GNRO-2019/00045

SUBJECT: Emergency Plan, Revision 79

Grand Gulf Nuclear Station, Unit 1
NRC Docket No. 50-416
Renewed Facility Operating License No. NPF-29

Rev 79 Change Summary

FIGURE 6-2

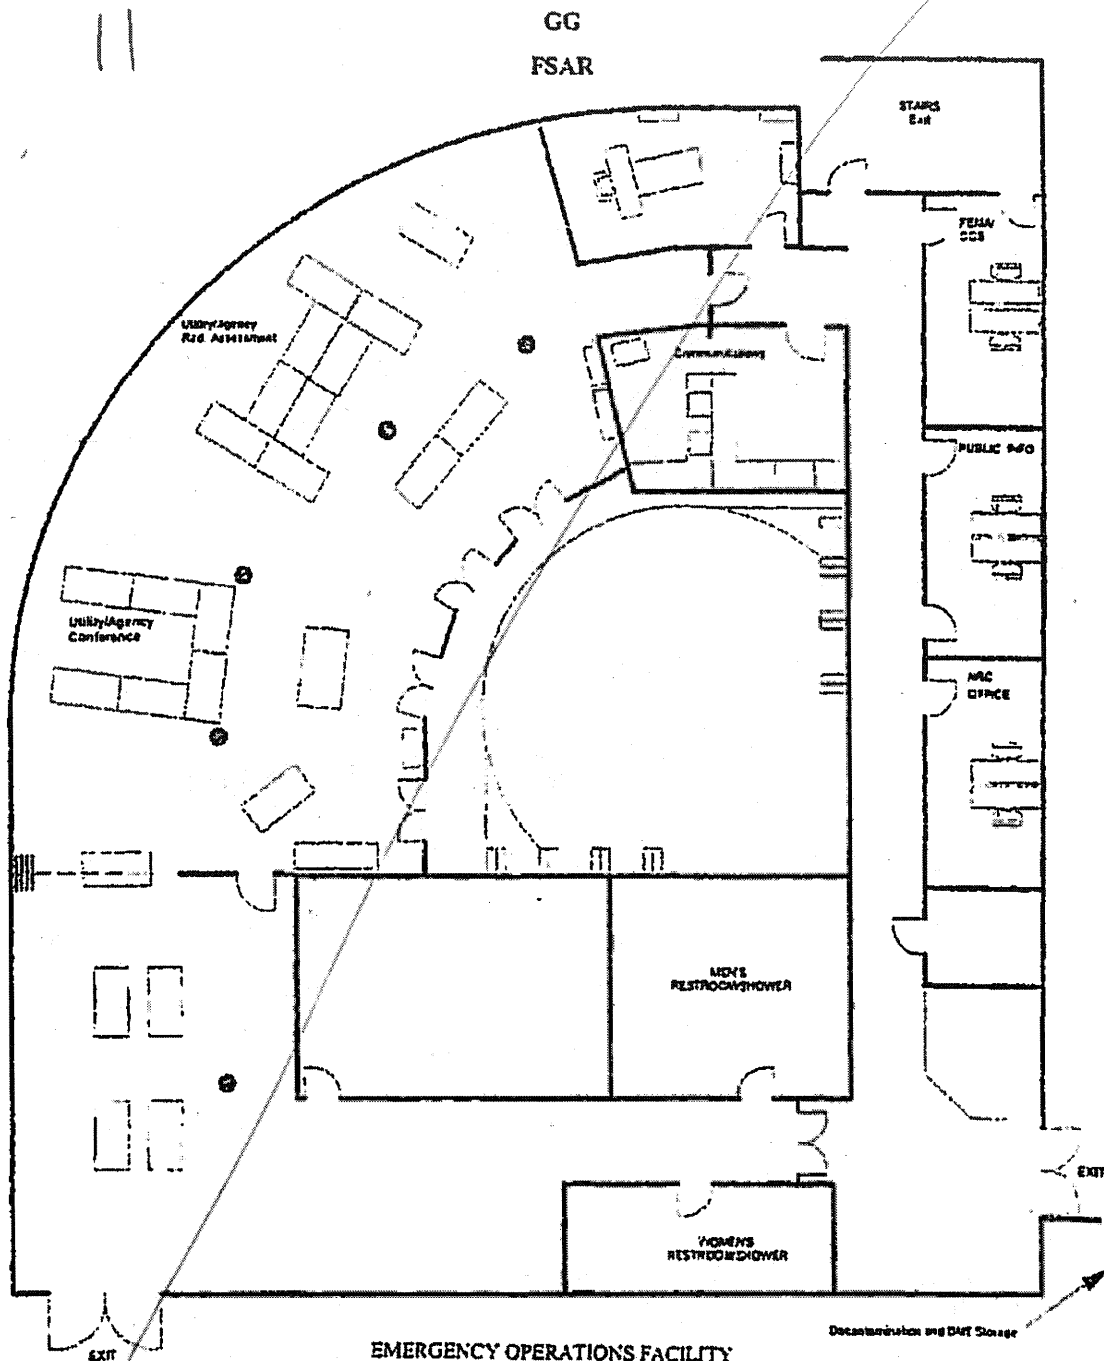
10	6-16	Fig 6-2	Changed example Emergency Notification form to an example of the current-form
11	7-26	Fig 7-4	Updated Fig 7-4 to a legible version and updated map of EOF. No changes were made to the map.
12	7-27	Fig 7-5	Updated Fig 7-5 to a legible version and updated map of EOF. No changes were made to the map.
13	7-11	7.5.4	Revised "Public Information publication" to read "GGNS Emergency Preparedness Public Information website and mobile application"
14	8-9	8.4.f	Added sentence: "This includes ensuring the accuracy of the information contained in the Grand Gulf Emergency Preparedness Public Information website and mobile application."
15	8-12	8-7	Revised "This information is disseminated via and Emergency Public Information publication mailed annually..." to read "This information is disseminated via a Grand Gulf Emergency Preparedness Public Information website and mobile application and postcard mailed annually..."

replaced with
Current Form

LEVEL I
FIGURE 7-4

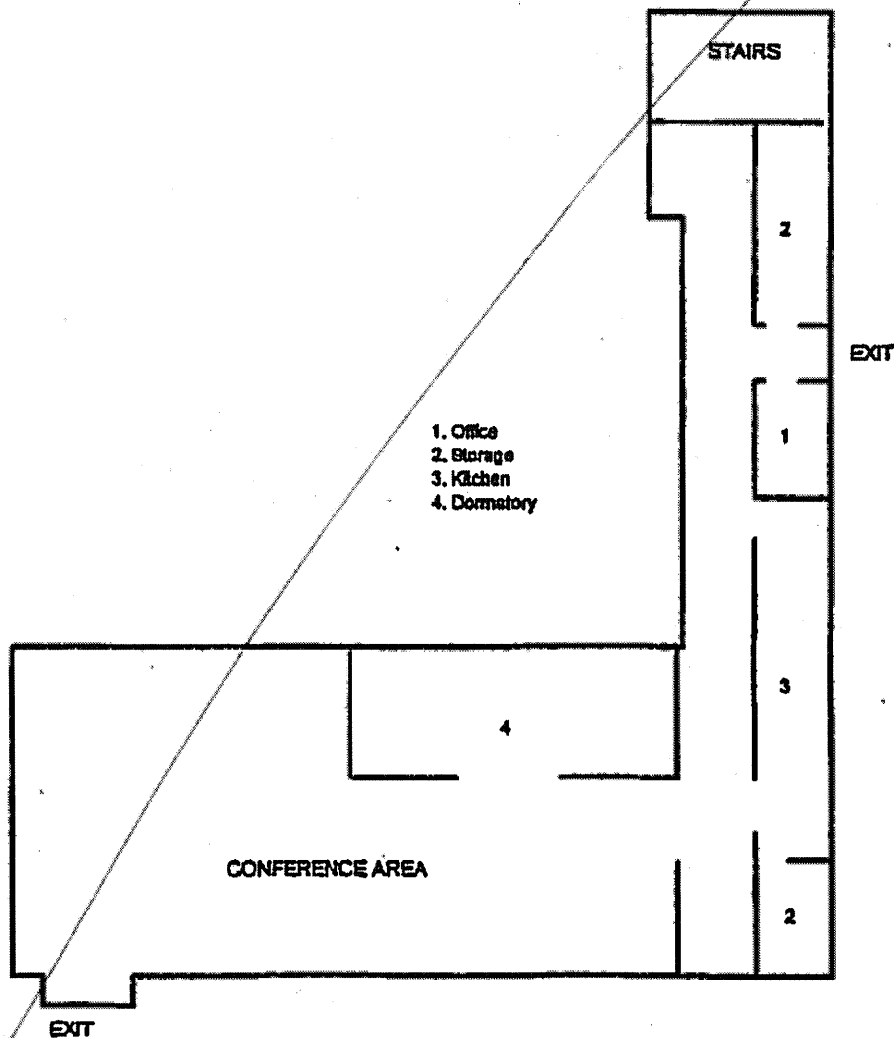
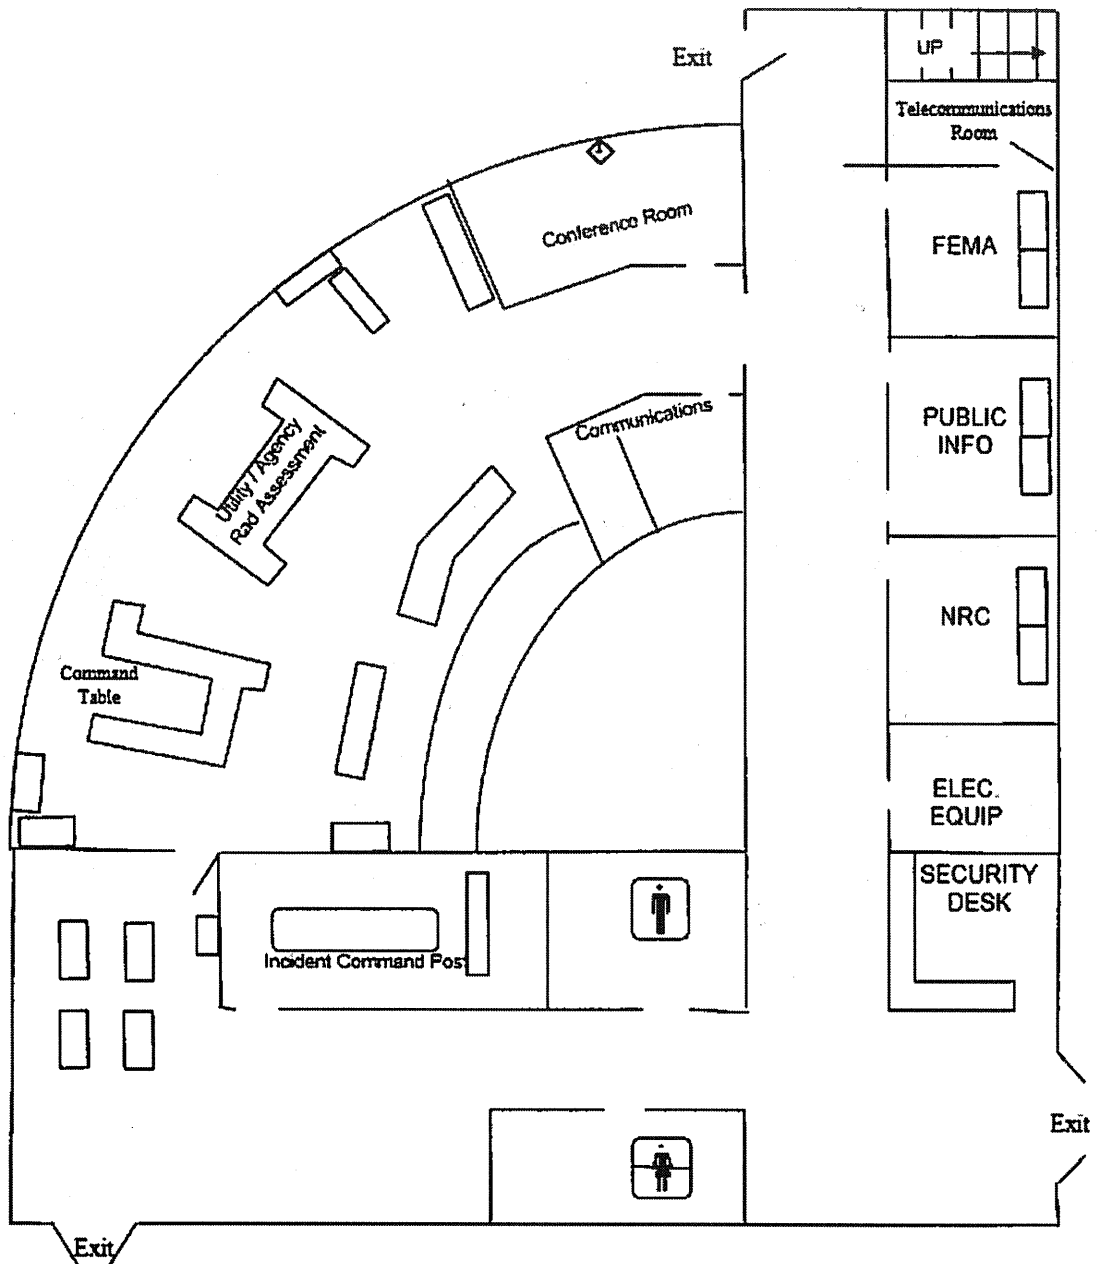
Change
Number
11

replaced
with
Clean Copy
